Re: Towbes Foothill Centre/ Sansum Clinic Proposal/ Traffic Safety Hazards
Cieneguitas Reorganization: Annexation to City of Santa Barbara(LAFCO 12-4)

Subject: Proposed Cieneguitas Reorganization; Response to letter from Rosanne and James Reid

SANSUM AT FOOTHILL CENTRE PROJECT ANNEXATION TO CITY OF SANTA BARBARA: RESPONSE TO COMMENTS FROM MS. REID

Foothill Centre • The Towbes Group • 12-7-09 • Map - Photo Simulation Locations

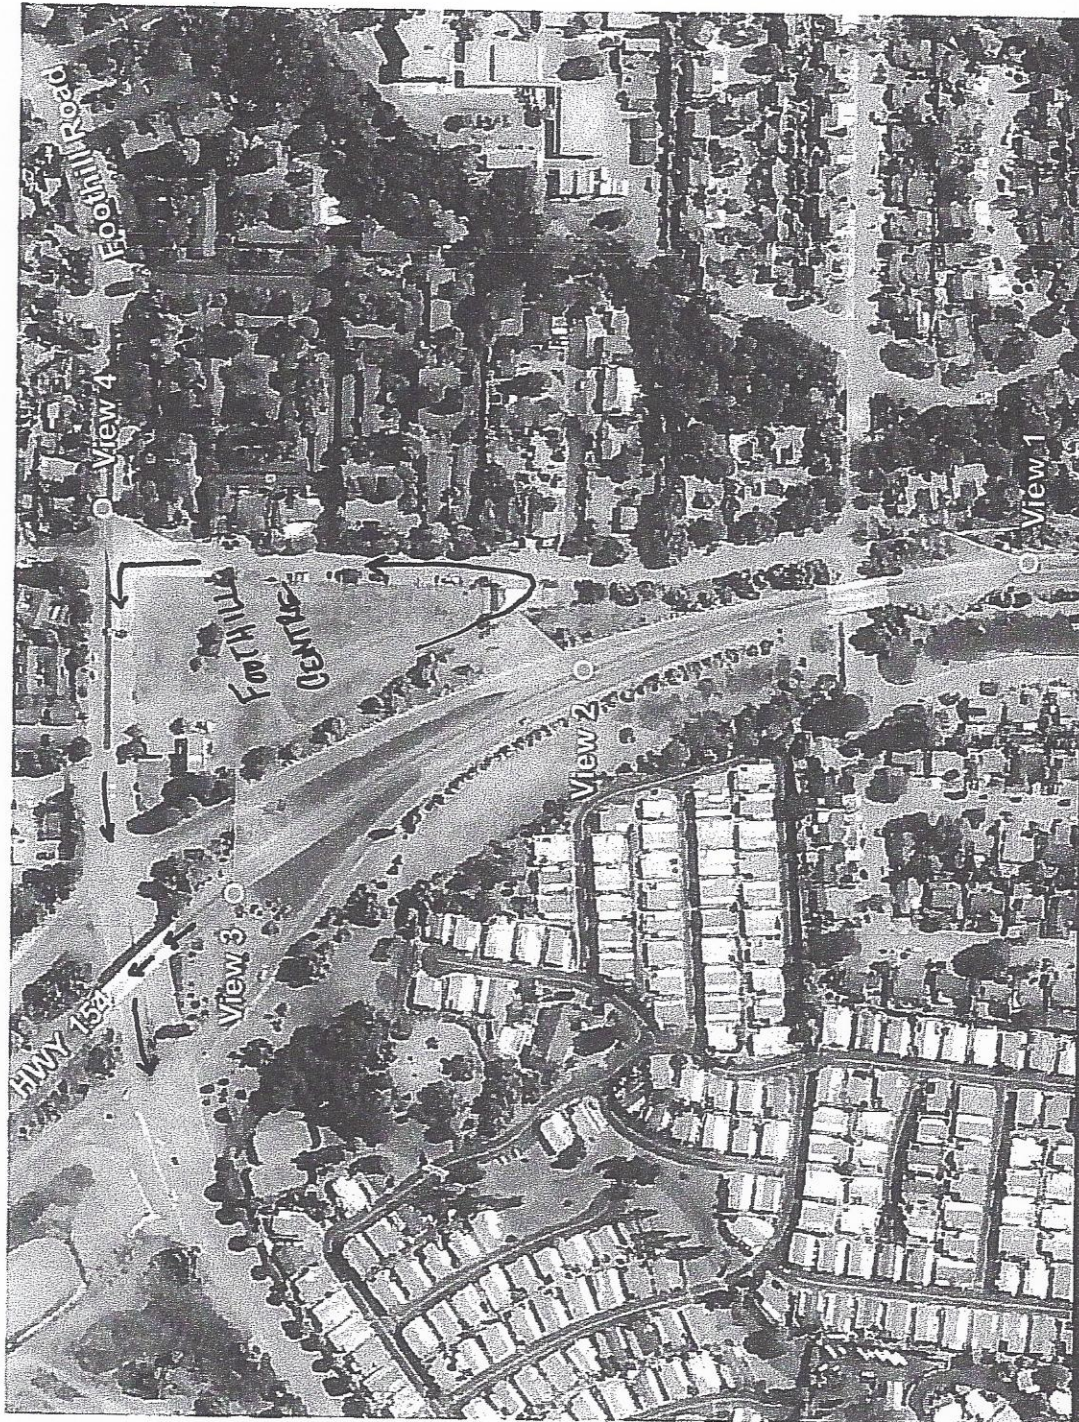
When we return home from Santa Barbara, we take 154 northbound, exit at Foothill/Cathedral Oaks, and turn left. It is difficult under existing conditions to make this turn, because the intersection has very poor sight distance. The problem is that the intersection is not a 90 degree configuration. To see what is coming from the Foothill/Cieneguitas intersection, one must turn about 130 degrees. For those of us without eyes in the back of our heads, it is very hard to tell what's coming from the east without pulling into the middle of Foothill. I am attaching an aerial photo showing this intersection. Often there are multiple cars stuck in the

Those of us turning left from 154 onto Cathedral Oaks have more to worry about than poor sight distance, preventing us from seeing what is coming from Foothill/Cieneguitas. We also have the speeding traffic proceeding east towards Santa Barbara on Cathedral Oaks. The posted speed limit is 45 mph, but the traffic moves much faster than this. The County or CalTrans frequently have mobile speed monitoring devices in place on Cathedral Oaks, which display motorist speeds, but these have little effect in slowing these drivers.

With regard to sight distance, the SR 154 northbound ramp at Foothill Road complies with Caltrans Highway Design Manual standards for intersections of this type. The City's Supervising Transportation Engineer Derrick Bailey conducted a site visit and determined that the Caltrans intersection meets the Caltrans sight distance standard of 385 feet for this section of Foothill Road, posted at 35 mph. Sight distance would also be increased with the removal

A field review was conducted to determine the available sight distance for vehicles making a left-turn from the SR 154 Northbound Off-Ramp onto Cathedral Oaks Road. The review found that the sight distance for a driver looking to the east from the SR 154 Northbound Off-Ramp extends beyond the traffic signal at the SR 192/Cieneguitas Road intersection. The field measurement determined that there is over 600 feet of sight distance looking to the east. The review also found that the sight distance looking to the west extended to the horizontal curve in Cathedral Oaks Road. The field measurements determined that there is over 630 feet of sight distance looking to the west. These sight distances exceed the Caltrans minimum sight distance requirements for vehicles traveling at 35 MPH, 45 MPH and 50 MPH. Table 1 summarizes the sight distance data for the intersection.

Intersection	Looking East		Looking West	
	Required(a)	Provided	Required(a)	Provided
SR 154 NB Ramps/Foothill Road	495 Feet	600 Feet	495 Feet	630 Feet
